SA Power Networks 2025/26 to 2029/30 Regulatory Proposal

# **REVIEW OF ASPECTS OF PROPOSED EXPENDITURE**

Report prepared for:  
**AUSTRALIAN ENERGY  
REGULATOR**  
August 2024

Figure 3.6: Historical and forecast overhead conductor failures

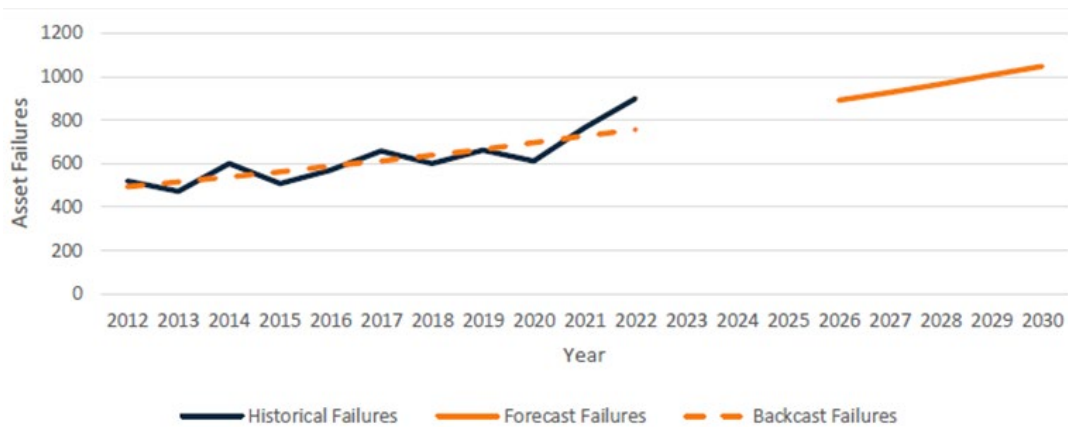
174. The PoF failure modelling developed by Fraser Nash assumes an increasing failure trend, consistent with Figure 3.6 and which is not consistent with more recent data that shows a flat to declining trend of failures for HV conductor, based on voltage level.

Figure 3.7: Historical and forecast overhead conductor failures – by voltage level

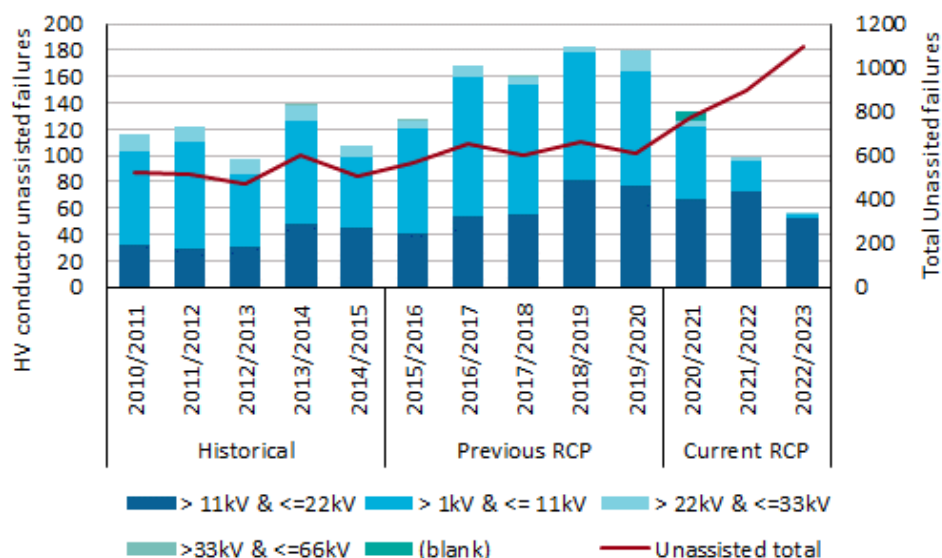
164. In Figure 3.7 we show the composition of HV unassisted conductor failures by voltage level, compared with the total unassisted conductor failure for all voltages. The trend of the HV conductor failures is clearly decreasing from a peak in FY20, whereas at a total level the number of failures follows the same curve as provided by SAPN in Figure 3.6. We find this insight curious, given the focus of the proposed expenditure is on the treatment, including replacement, of HV conductors and not LV conductors.

Figure 3.8: Predicted versus observed HV conductor failure rate

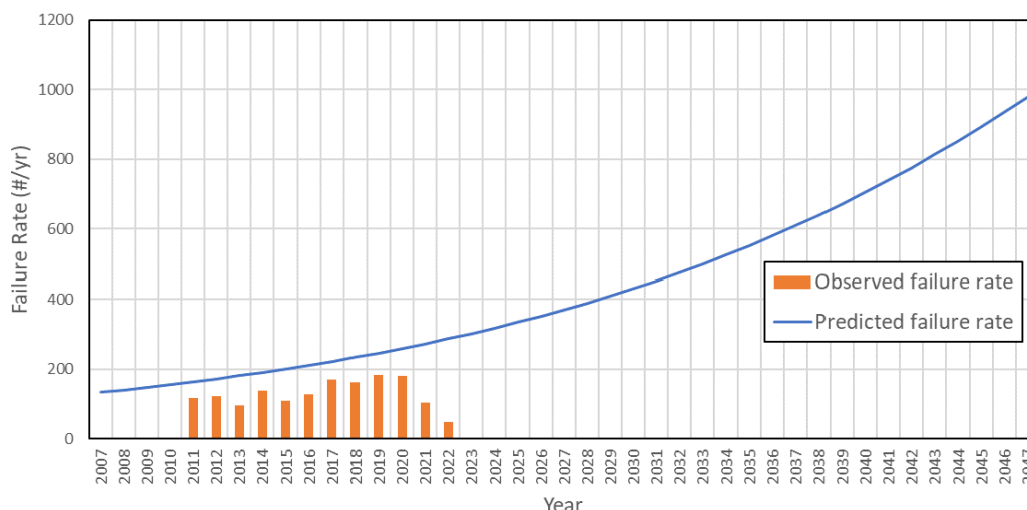
177. Based on our own analysis of the source data, and as indicated by Figure 3.8, the observed failure rate of HV conductors has been decreasing, and any interpretation of this is therefore sensitive to the averaging period that has been selected, to take account of the impact of other preventative replacement strategies.
178. We understand that SAPN has undertaken back-casting of its conductor failures, to verify the rate of change in probability of failure over time, using the same probability of failure modelling methods over ten years. We consider this is a useful indicator of the robustness of the model. We have not been provided the modelling that provided the back-cast data in Figure 3.6. SAPN states that:

Figure 4.3: SAPN’s capacity-driven augex forecasting methodology

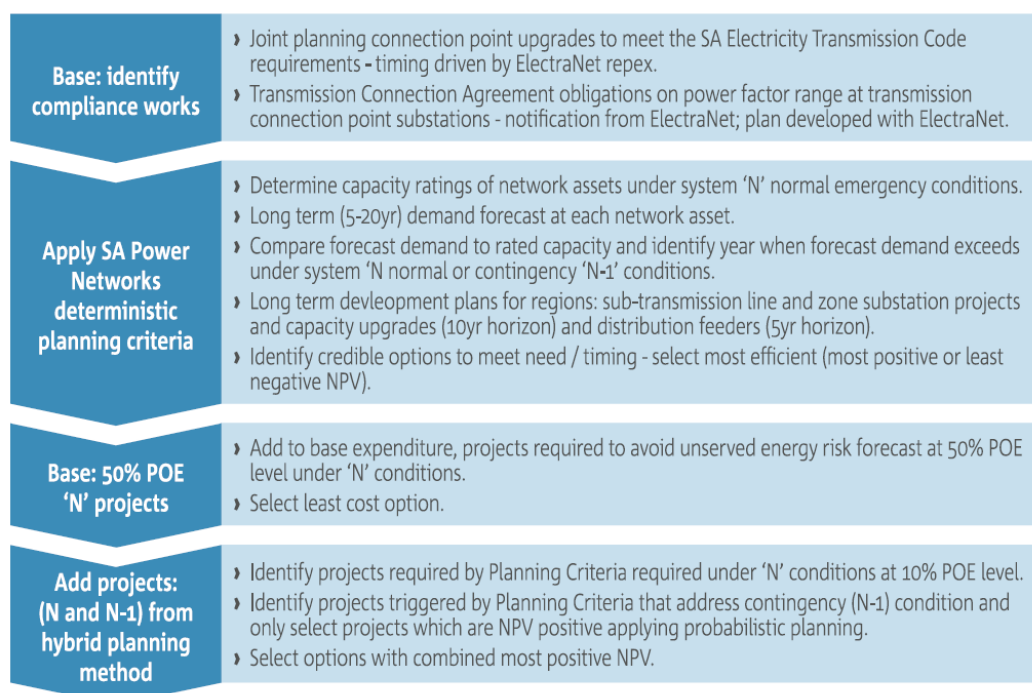
- 242. We note that neither Figure 4.3 nor Figure 4.4 explicitly includes consideration of non-network solutions, although as pointed out in section 2.6.1, this step is included in another SAPN document. We consider this further in our assessments of the proposed expenditure.

Figure 4.4: SAPN's capacity augex project selection process

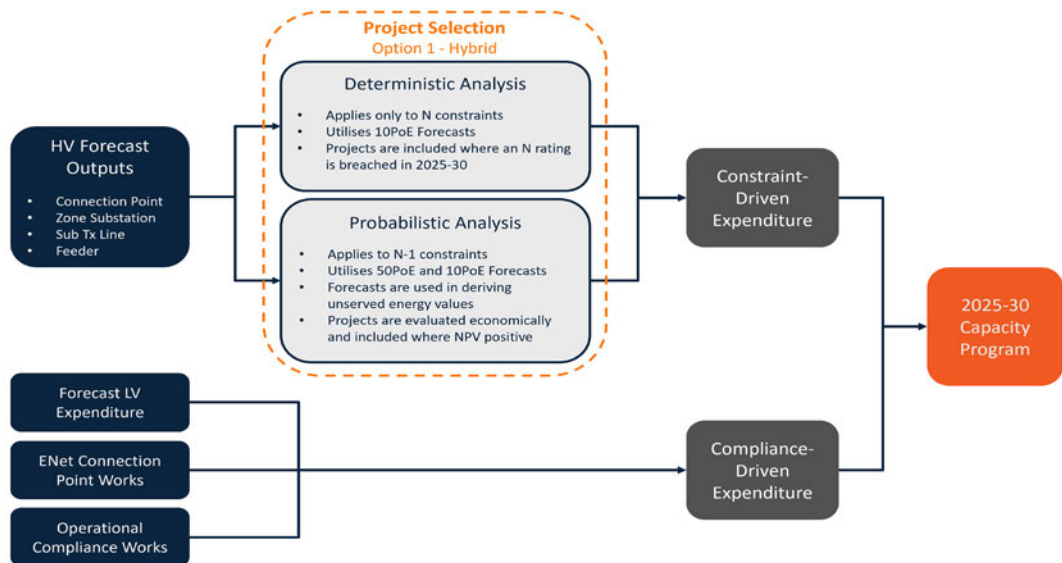
255. We make the following observations regarding the hybrid project selection approach shown in Figure 4.4 and which SAPN uses as its 'Option 1' in its options analysis, discussed above.

Figure 4.6: SAPN’s historical and forecast expenditure for LV QoS augex (AUG002 and AUG010) \$million, \$FY22

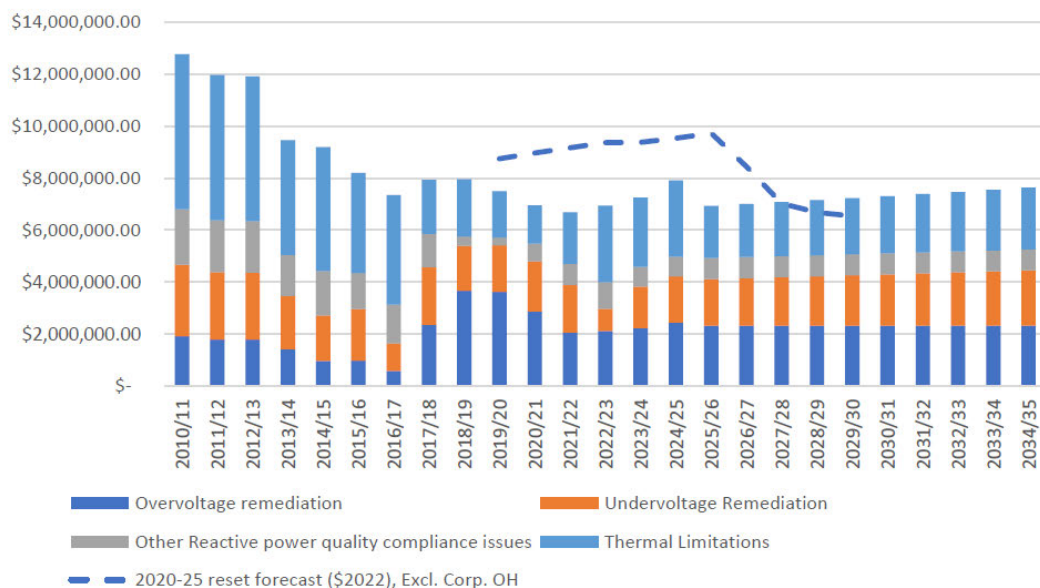
302. SAPN's historical and forecast expenditure for AUG002 (undervoltage, thermal and other) and AUG010 (overvoltage) is shown in Figure 4.6, although we note that the extension of the 2020-25 reset forecast into the current RCP is unexplained by SAPN. It would also appear from the profile that the expenditure is expressed in nominal terms, given that SAPN has proposed flat annual expenditures for both AUG002 and AUG010.<sup>87</sup>

Figure 4.7: Reliability augex historical (\$m, FY25)<sup>93</sup>

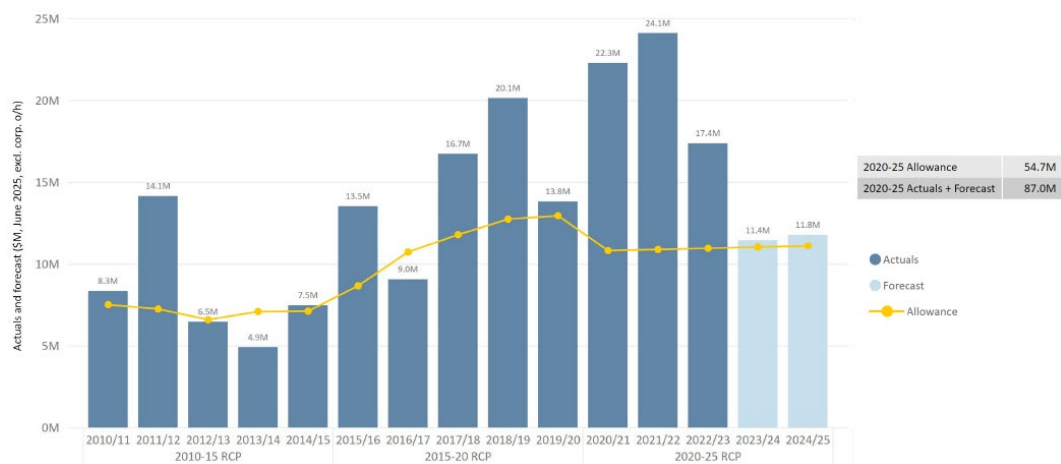
312. The forecast expenditure for the current RCP is \$87 million,<sup>92</sup> which is well above the AER allowance of \$54.7 million, as shown in Figure 4.7.
313. SAPN's expenditure has ramped up significantly over the last decade, with expenditure significantly above the AER's allowance in FY21, FY22 and FY23 an expected reversion to the annual allowance in the last two years of the RCP. SAPN does not explain the reason for this pattern of expenditure, although we infer that SAPN assumed it had done enough to affect the required impact on underlying reliability performance through the three years of significant overspend.

Figure 4.8: SAPN distribution system SAIDI performance, targets, and expenditure (\$m, FY25)

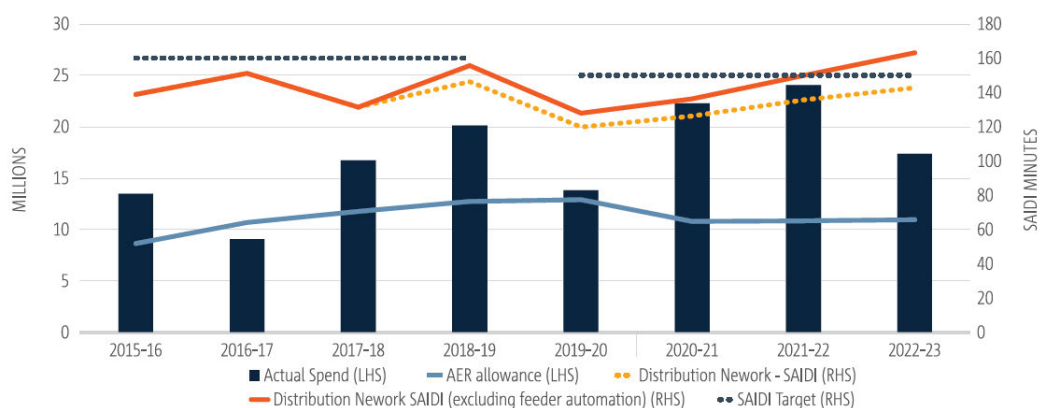
- SAPN advises that its response was to prevent breaches of its jurisdictional targets but as shown in Figure 4.8, in FY21 and FY22 System Average Interruption Duration Index (SAIDI) was well under target (and, as discussed below, well under the SAIFI target):

Figure 4.13: SAPN’s reliability performance, actual spend, AER allowance - underlying reliability program (\$m, 2022)

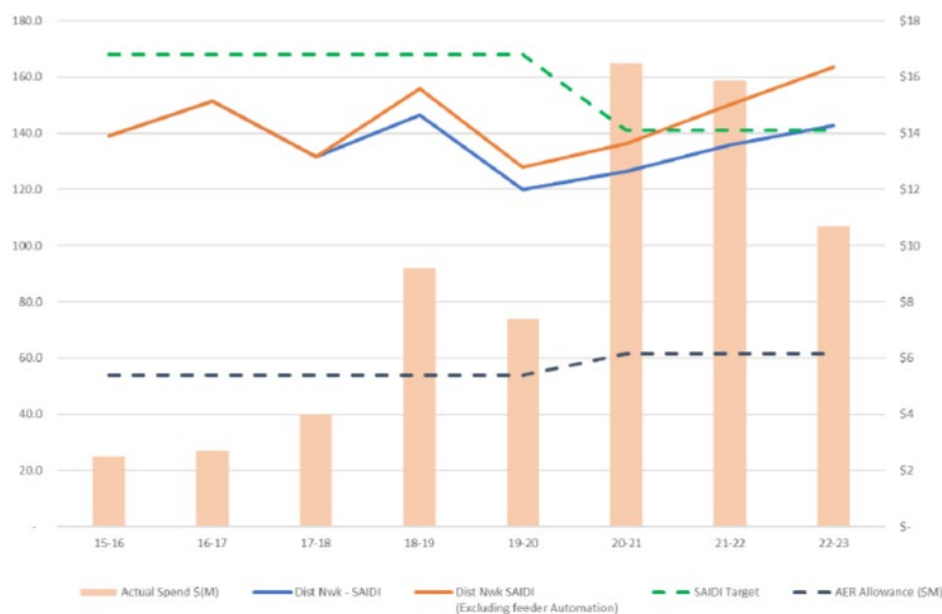
334. Figure 4.13 shows the expenditure increase above the AER’s allowance since FY19. We note that SAPN has inferred a ‘whole of network’ SAIDI target from the EDC feeder category targets as 140 minutes in this figure, whereas in Figure 4.8 the SAIDI target is set at 150 minutes. Our understanding is that the correct figure is 150 minutes.

344. In our view SAPN has not provided evidence that it has optimised its expenditure in the current RCP to address SAIFI and SAIDI. Moreover, given the significant volatility in its annual expenditure, as evident in Figure 4.13, SAPN's reference to needing to continue expenditure at least at 'recent actual levels' leaves considerable latitude for interpretation, depending on the period of reference. We also note that a significant proportion of the expenditure was directed to activities that favour SAIFI improvement and that did not appear to be required to the extent we infer from the information provided.

351. Whilst we consider that maintaining underlying reliability is appropriate, we do not consider that SAPN has justified the significant increase in expenditure that it is proposing for the next RCP. We suspect that SAPN is likely to be able to provide more compelling information to support its proposed expenditure on this program including by reference to the FY24 performance in its RRP and a more extensive options analysis. In the interim we propose that its allowance is set at the average of the revealed cost over the last eight years shown in Figure 4.13.

Figure 4.15: Increasing incidence of lightning ground strikes

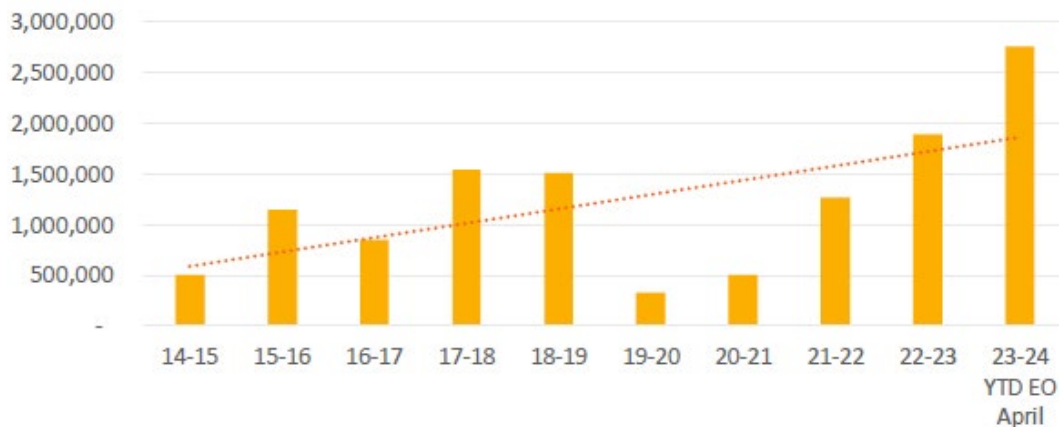
- increased frequency of lightning strikes
    - expected increase in grey-headed flying fox colonies.<sup>103</sup>
339. Figure 4.15 shows the increasing incidence of lightning strikes through to April 2024. SAPN also refers to wind-borne vegetation as a second driver of the increasing impact of weather on SAIDI.<sup>104</sup> SAPN does not provide statistics to support its assertion regarding vegetation, although it is reasonable to assume that the impact of lightning is increasing.

Figure 4.23: Eyre Regional - ranked projects – benefit versus costs (\$,000 2022)

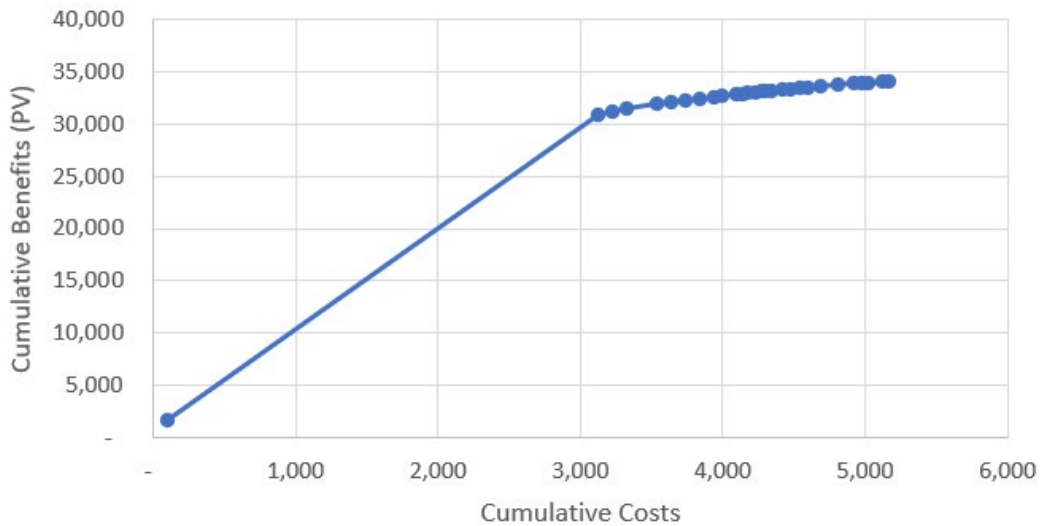
379. The pattern in Figure 4.23 is similar for the other two regional sub-programs. Whilst the NPV for some projects is marginal, we are satisfied that:
- there is no undue bias in the benefit or cost analysis;
  - SAPN has appropriately excluded feeders from this program where there is duplication with the rural long program; and
  - there are no projects where there is a disproportionately low cost-to-benefit ratio.
380. We therefore conclude that the proposed expenditure for this program is reasonable.
